September 12, 1994

Re: Pasco County  
Materials Recovery Facility  
Pending Permit No. SC51-252834

RE: Materials Recovery Facility, Pasco County  
Pending Permit No. 8C51-252834

Re: Pasco County  
Material Recovery Facility  
Pending Permit No. SC51-252834

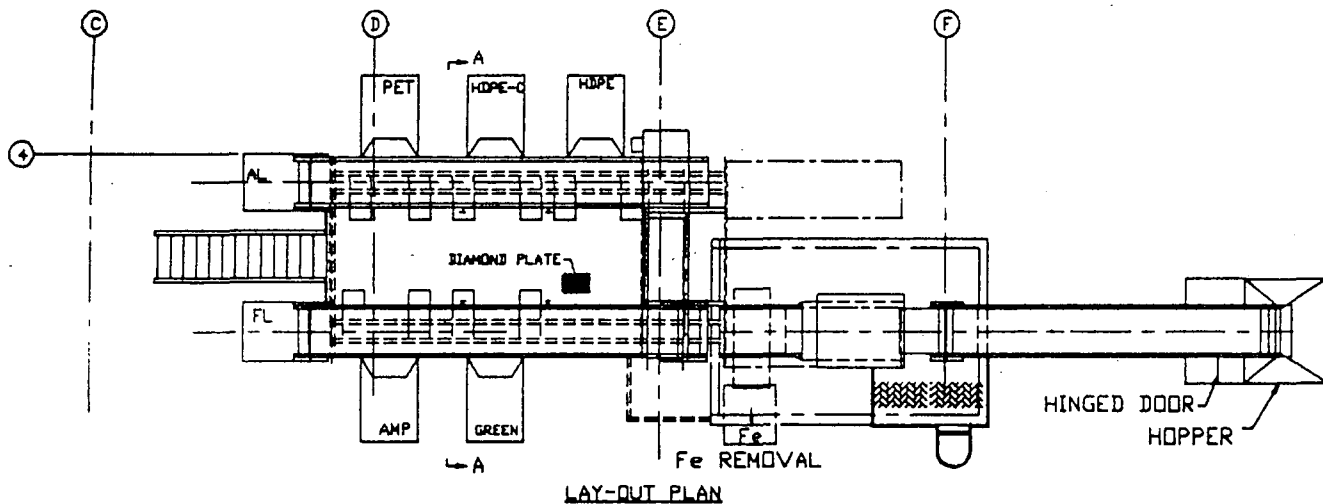
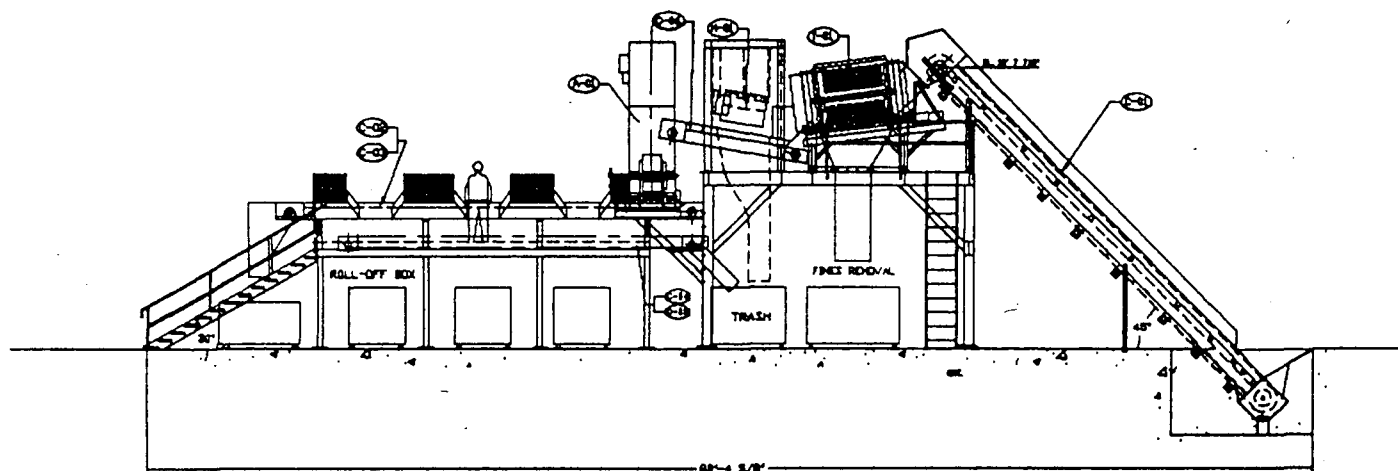
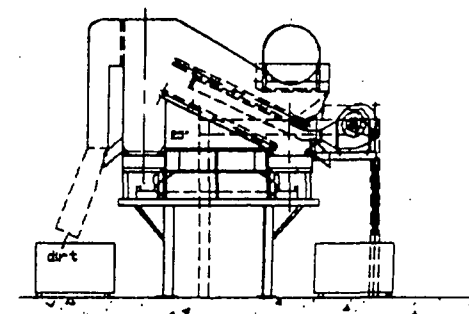
**Comment #2:** The information submitted indicates that the "sorting system [including the trommel, air classifier, and magnet] and its conveyor are shown on the Drawings on Sheet 3." However, the trommel, air classifier and magnet are not shown on Drawing 3. The system shown on Drawing 3 indicates a hand-sort operation only, with a single conveyor and six storage bins for separated materials. Trommels, air classifiers and magnet systems typically have two output streams, each with a specific associated conveyor or discharge bin. (Please revise Drawing 3 to show the trommel screen, air classifier, magnet and associated conveyor systems.)

The information submitted indicates that "glass containers will be hand sorted from the heavy fraction conveyor line on the sorting system and placed into self dumping hoppers...[and then into] glass storage bunkers." Which conveyor line on drawing 3 is the "heavy fraction conveyor line"? Please show the "heavy fraction conveyor line on Drawing 3 or other appropriate Drawing. After the glass is placed in the storage bunkers, how often is it removed for recycling or disposal? How is the glass removed from the bunkers?

1. The information submitted indicates that bags will be removed manually. Will the bags be disposed of or recycled? Is this quantity included in the residual stream of 5-10%?
2. The information submitted indicates that the "sorting system [including the trommel, air classifier, and magnet] and its conveyor are shown on the Drawings on Sheet 3." However, the trommel, air classifier and magnet are not shown on Drawing 3. The system shown on Drawing 3 indicates a hand-sort operation only, with a single conveyor and six storage bins for separated materials. Trommels, air classifiers and magnet systems typically have two output streams, each with a specific associated conveyor or discharge bin. Please revise Drawing 3 to show the trommel screen, air classifier, magnet and associated conveyor systems.

5. The information submitted indicates that "glass containers will be hand sorted from the heavy fraction conveyor line on the sorting system and placed into self dumping hoppers...[and then into] glass storage bunkers." Which conveyor line on drawing 3 is the "heavy fraction conveyor line"? Please show the "heavy fraction conveyor line" on Drawing 3 or other appropriate Drawing. After the glass is placed in the storage bunkers, how often is it removed for recycling or disposal? How is the glass removed from the bunkers?

**Response:** Drawing #3 did not show the trommel, air classifier and magnet. The attached drawing from our equipment vendor shows these

features. The trash conveyors are located beneath the two sorting lines and travel in a reverse direction to discharge in the trash container located under the magnet.

The heavy fraction conveyor line is the bottom line shown in the layout plan on Drawing H94171-1. It is directly adjacent to the containers marked "Green", "AMB", and "FL".

- 2) Drawing #3 did not show the trommel, air classifier and magnet. The attached drawing from our equipment vendor shows these features. The trash conveyors are located beneath the two sorting lines and travel in a reverse direction to discharge in the trash container located under the magnet.
